**RE: DSUP #2018-0028  
2395 Mill Road  
Narrative to Accompany Application for DRB Meeting on July 18, 2019**

**RE: DSUP #2018-0028  
2395 Mill Road  
Narrative to Accompany Revisions to DRB Meeting #3 Submission Documents of July 3,  
2019**

# 2395 MILL ROAD OFFICE BUILDING

## EISENHOWER EAST DESIGN REVIEW BOARD SUBMISSION

**01 WEST ELEVATION**  
SCALE: 3/32" = 1'-0"

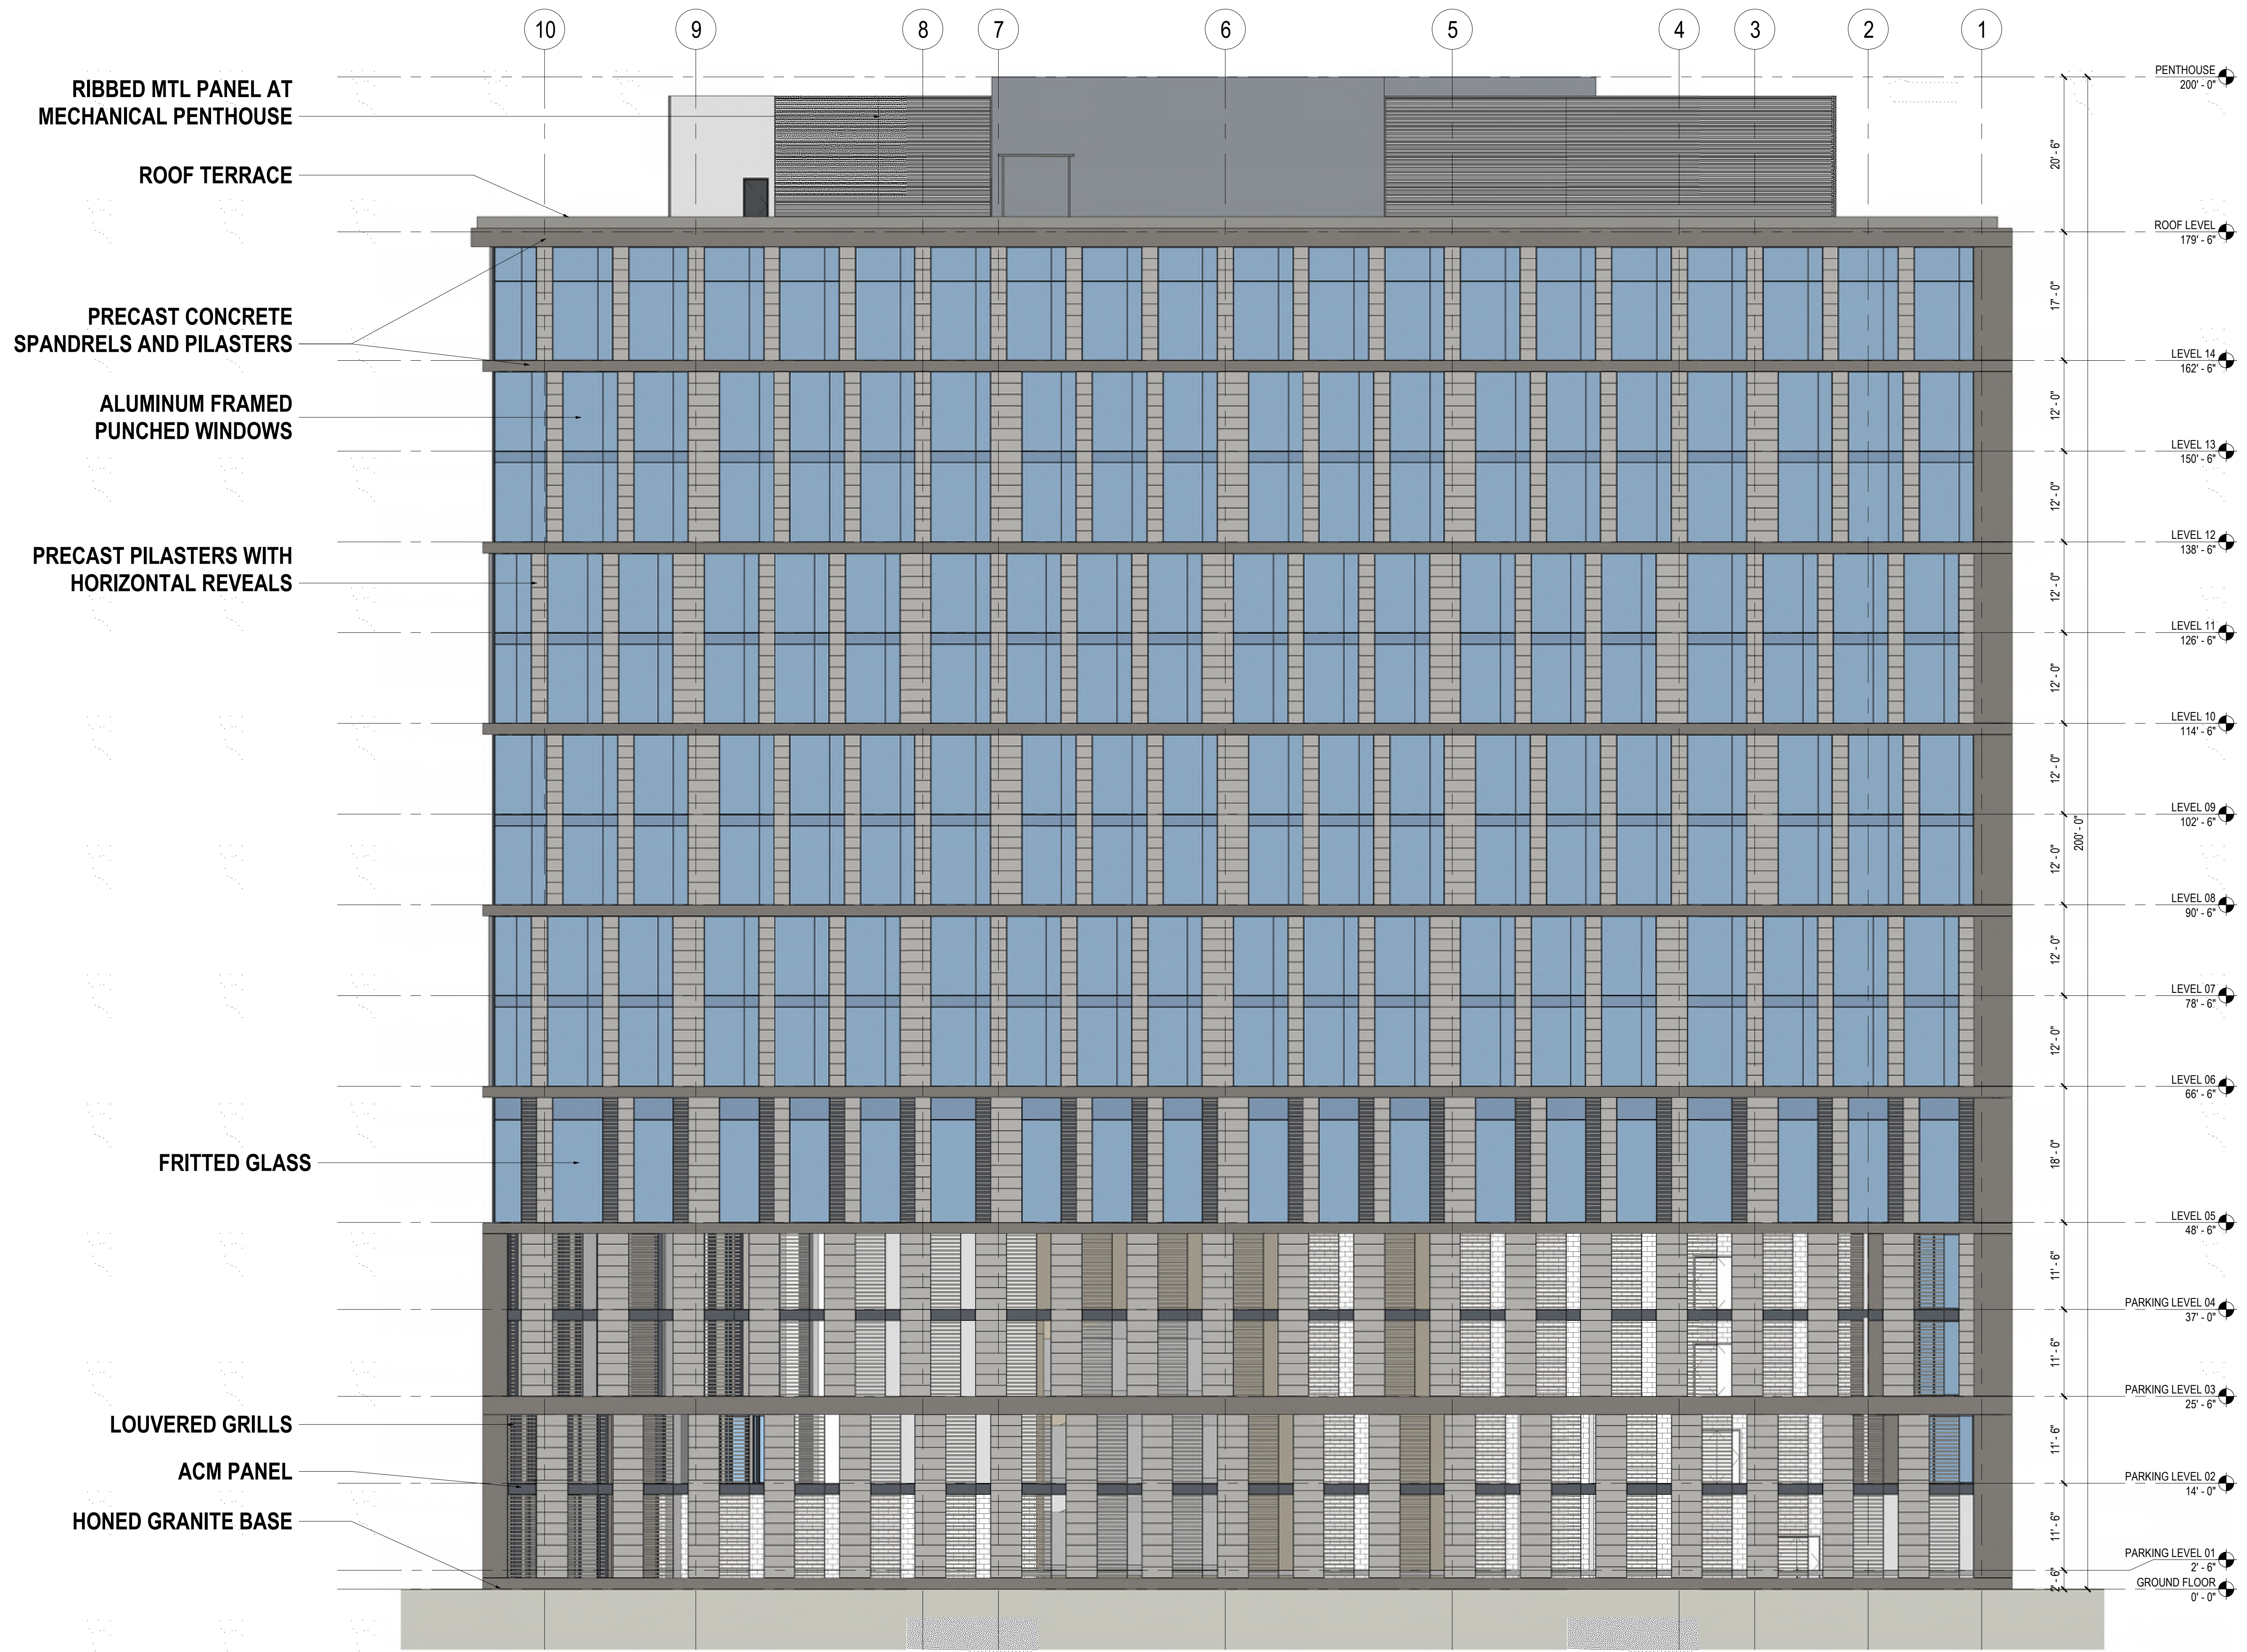
- The West façade “back bar” design updated, and lower 4 levels of West façade simplified;
- Square columns at level 5 changed to round columns to carry through design at ground floor level and evoke classic WMATA design element, and;
- A Material Sample Board has also been added to the submission.
